3 - 6 Spring Place  
Spring Place Ltd

Comments Response  
Access  
November 2016

LONDON BOROUGH OF CAMDEN

**Re: 3 - 6 Spring Place, London, NW5 3BA**

## 1.0 Current proposed entrance - Revolving door

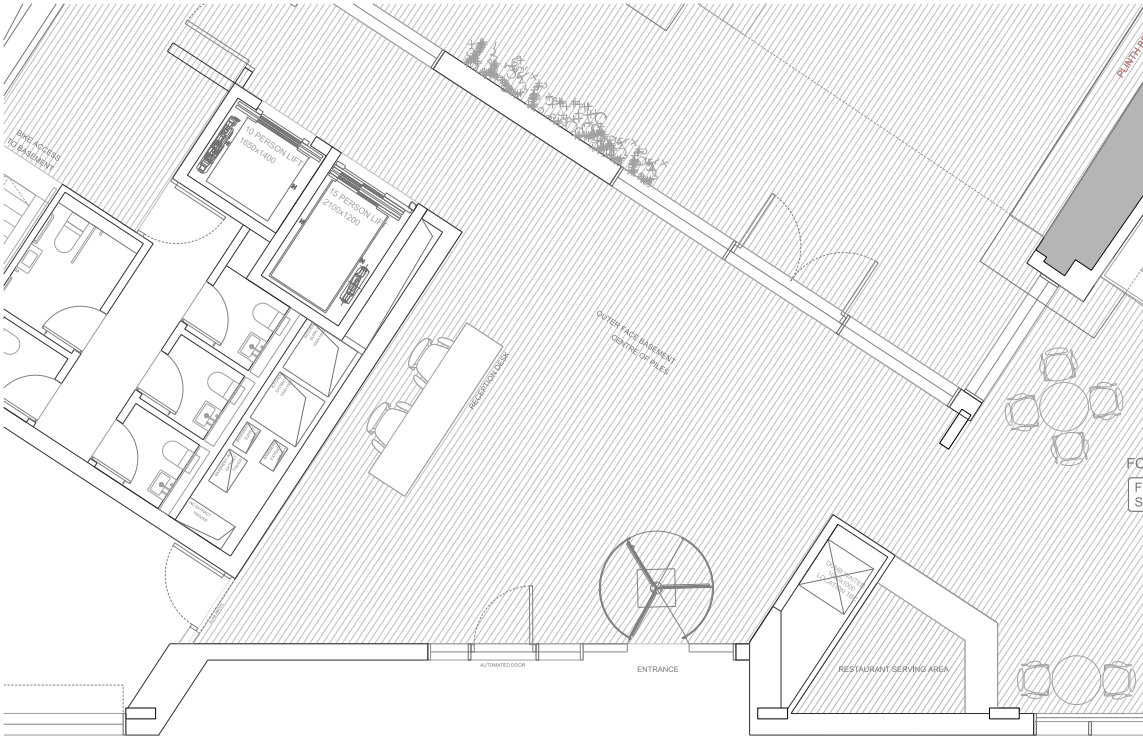
“It is disappointing that revolving doors and side pass doors are proposed at the main entrance. This entrance needs to be redesigned so a cohesive single entrance point is provided for all users. In my view these do not comply with Policy DP29 and section 29.4 which requires new buildings and spaces to be fully accessible to promote equality of opportunity. Furthermore the DAS talks about a ‘button controlled opening door’ all doors should permit the same level of access i.e. if there are no security controls for the revolving door there should be none for the side pass door.”

The Spring Place entrance into the building is designed for access to the building’s office floorspace as well as the event space and the café.

The installation of two types of door (a revolving door and a standard automatic door) allow for flexibility in access to suit different users and to adapt to the potential different ways the entrance will be used.

A revolving door is considered important for day-to-day use allowing efficient heating of the space and reducing heat loss and energy consumption. Use of the automatic door will be less during these periods and this dual access offers an important sustainability benefit.

During more intensive use of the ground floor event / café space, the intention is that the automatic door will be left open during peak usage and the revolving door will effectively become a secondary access. It is therefore not the intention that the two doors represent a primary access and secondary access and therefore it is not considered to represent any form of inequality of opportunity for use.

In response to Access Officers’ comments, button-controlled opening / security controls will be fitted to both the revolving and standard automatic doors to ensure equality in access opportunity.

Proposed Ground Floor

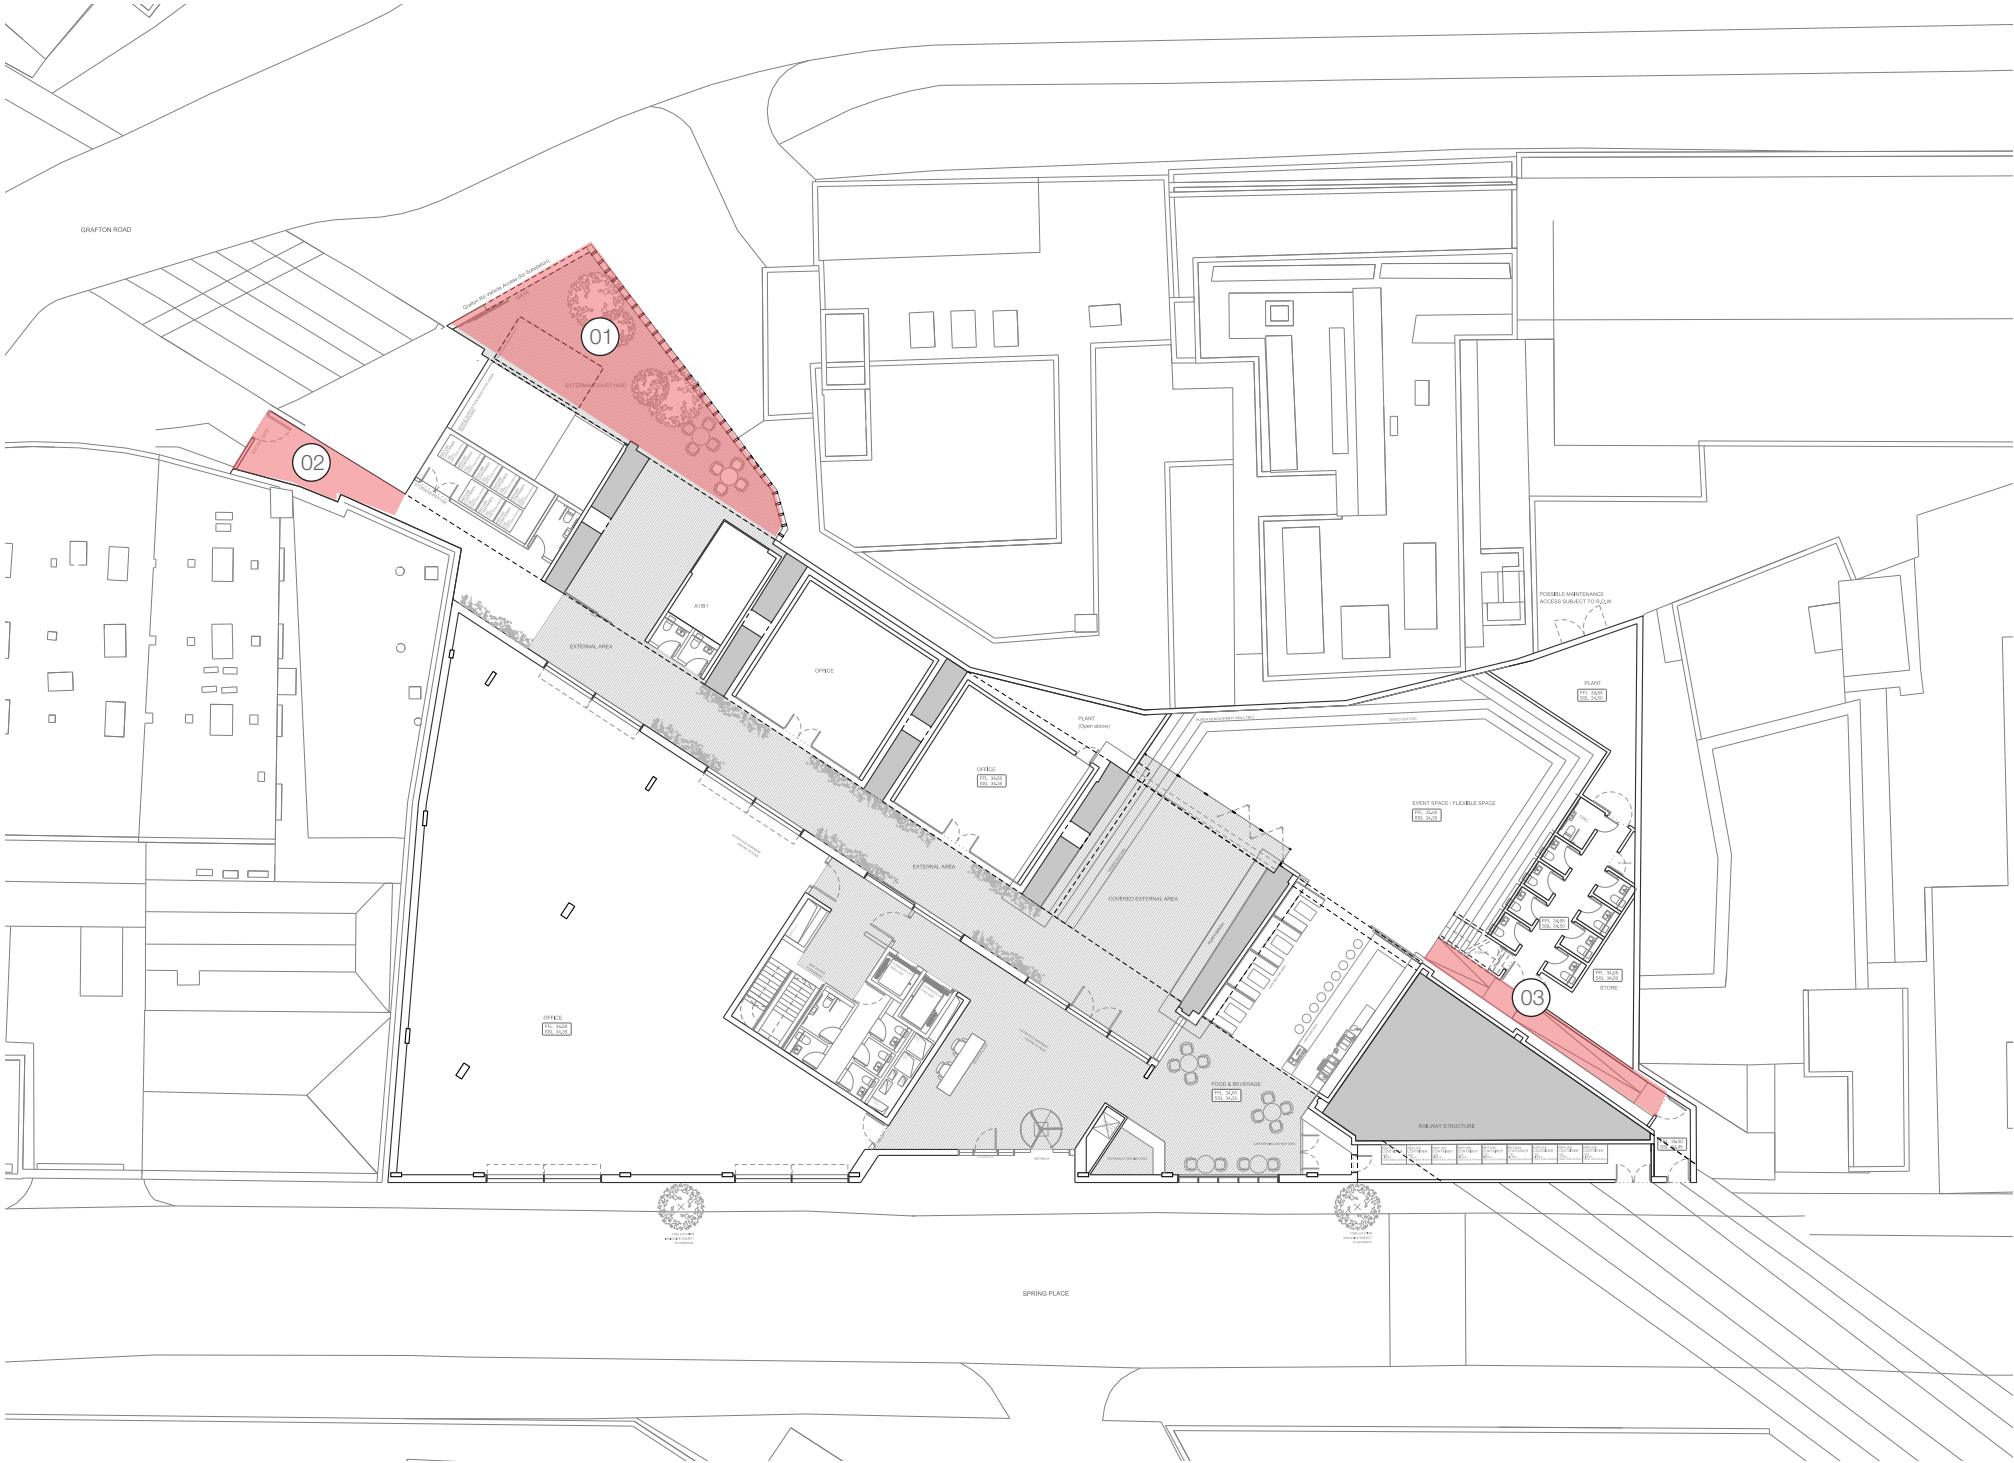
“There are a number of external ramps, conformation is sought that these will be 1500mm wide and have a gradient between 1:12 and 1:20 and that they will handrails on both sides which are continuous across mid landings. The ramp handrails should extend horizontally by 300mm beyond the top and bottom ramp and terminate in a closed ending.”

No level change: +/- 0mm\*  
\*New slab datum +34.50m creates level access subject to external survey

Level change: +/- 500mm\*  
Combined ramp length: >10000mm  
Gradient: Rise less than 1:20  
Minimum width: >1200mm  
\* Subject to external survey

Level change: +/- 500mm  
Combined ramp length: >10000mm  
Landing: >1200mm  
Gradient: Rise less than 1:20

Typical core arrangement

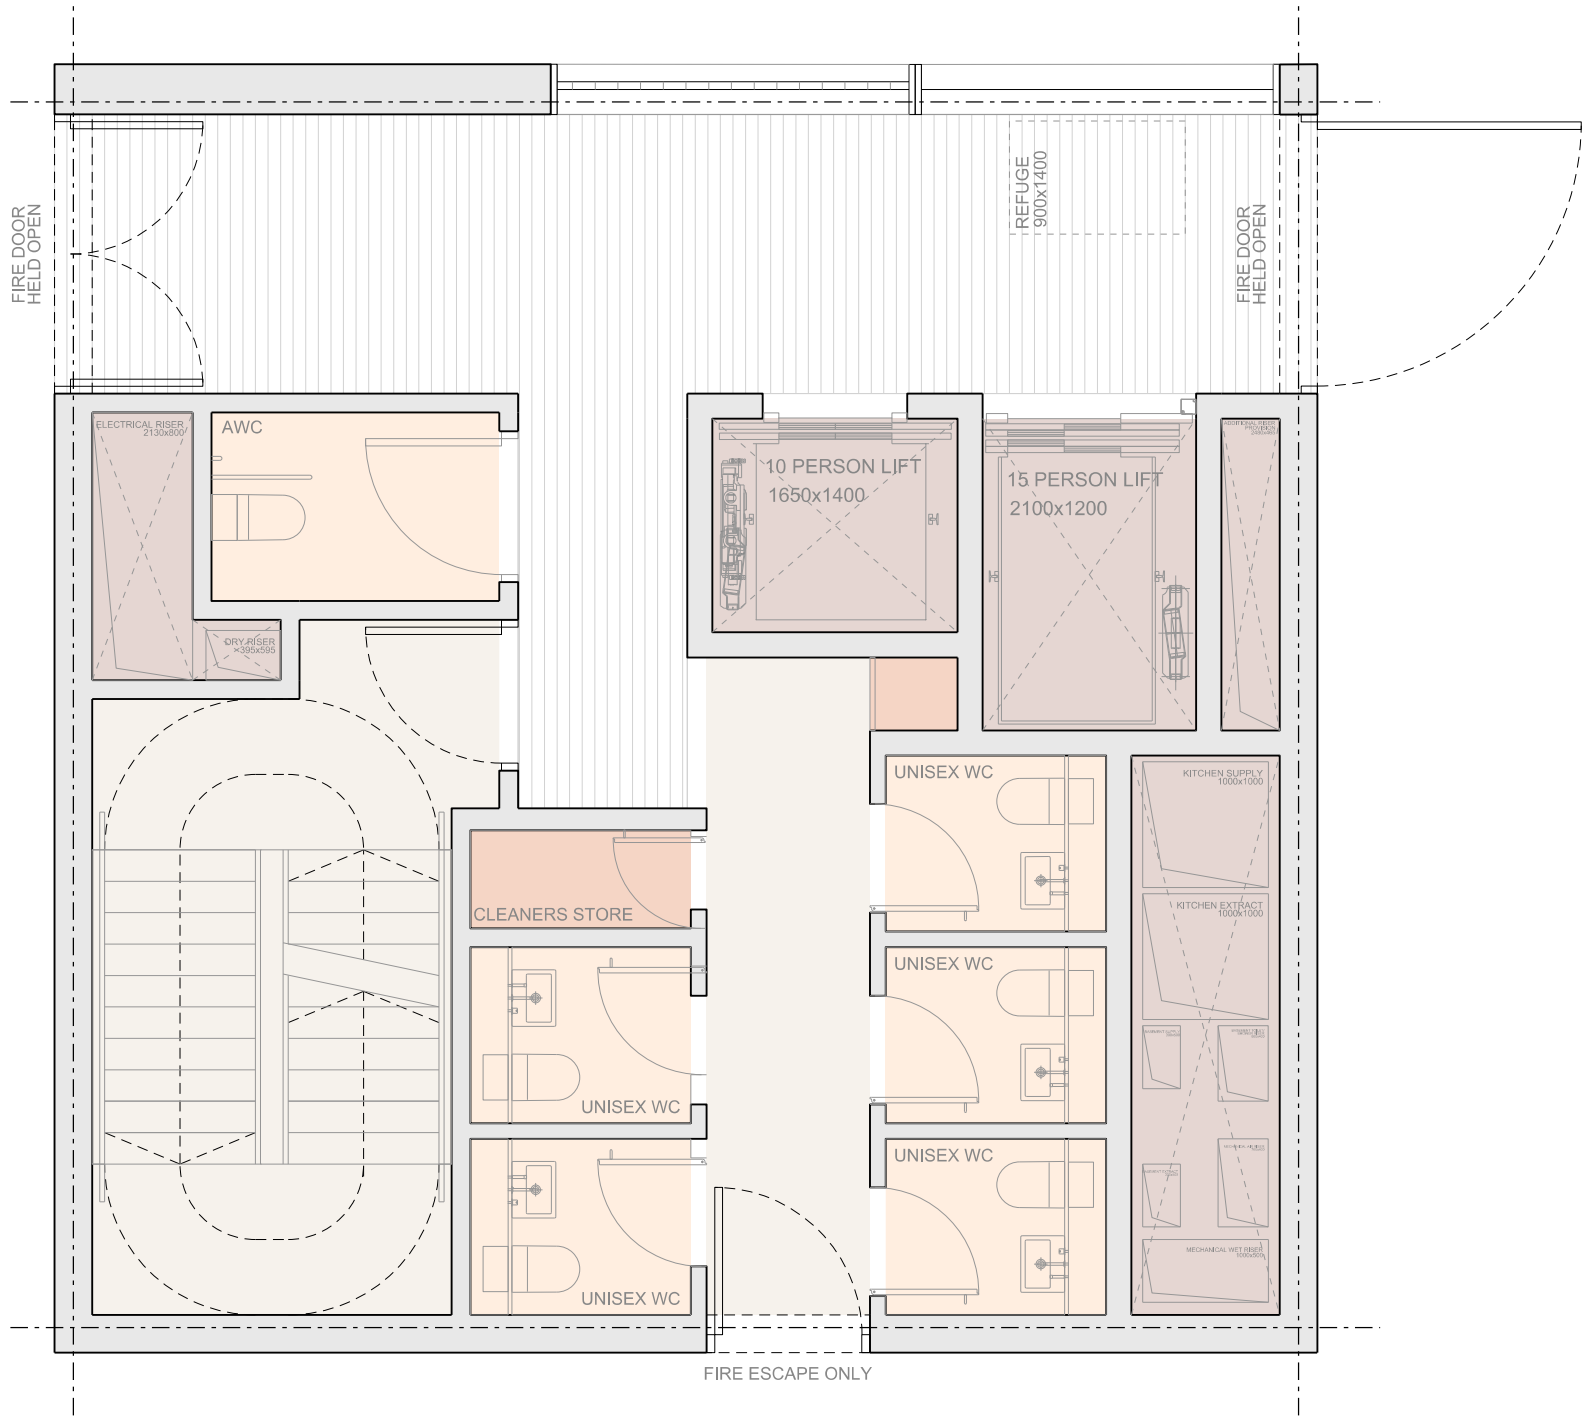
“All the wheelchair accessible unisex WC’s have inward opening doors which is very disappointing for a new build. No justification is made for this and no confirmation is provided that other options were explored or that a 1500mm turning circle clear of door swing and fixture and fittings is provided.’

View from the event space towards the cafe and public entrance

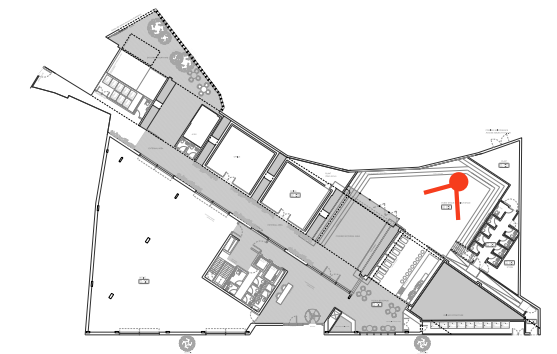
“The external seating should include some seating with back support and arm rests to assist ambulant disabled people when rising and lowering into seating.

“The tiered seating in the event space should include spaces for wheelchair users to sit beside other companions; no such provision has been included.”
